PROJECT STATUS	RIBA Stage 5
CLIENT	Manchester City Council
PROJECT	Our Town Hall
DRAWING TITLE	Lead roofing and cladding details to access dormer in roof slope WR24
SIZE & SCALE	A1: 1 : 5
DRAWING STATUS	For Construction
JOB NUMBER	236959
DRAWING NO.	OTH-PUR-TH-RF-DWG-A-7100 02
REV

Section A-A

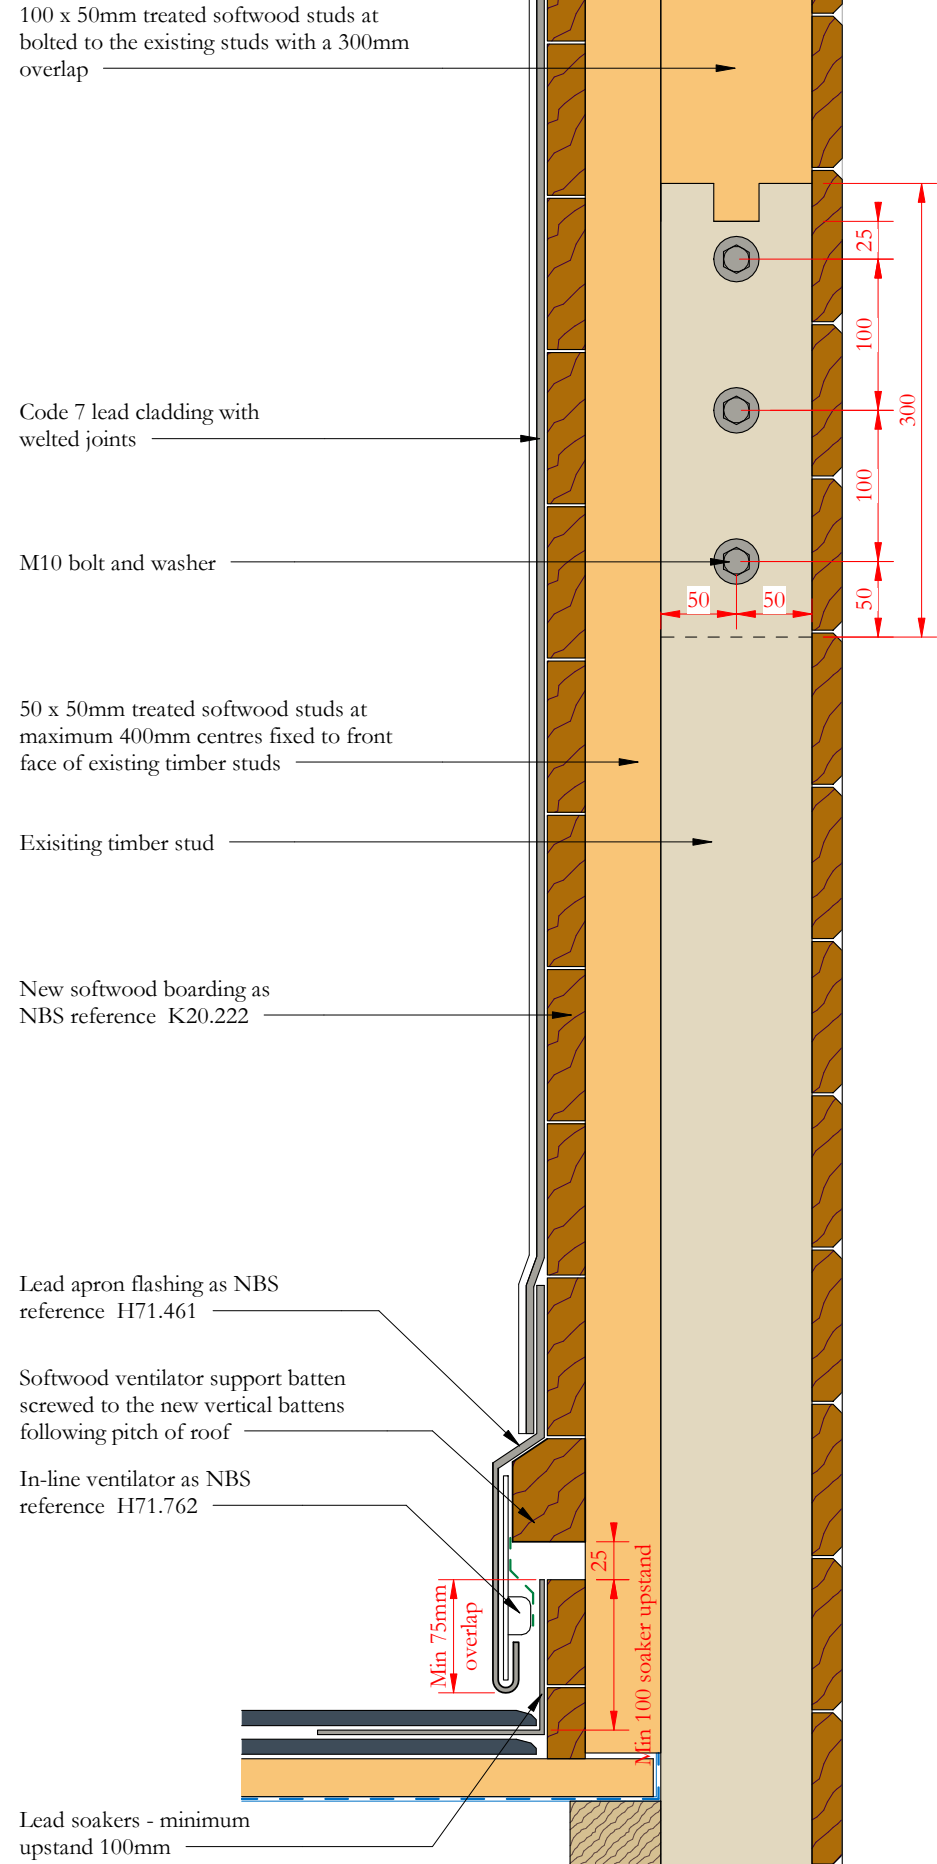
Revision 02: Height of dormer increased to accommodate full height access door. New door and frame indicated. New timber studs shown bolted to existing studs and new roof joists added.

Revision 01: Firrings on roof changed to 50 x 50mm battens following roof slope formed by existing joists. 50 x 50mm vertical battens added to sides of dormer. Door jamb detail added.
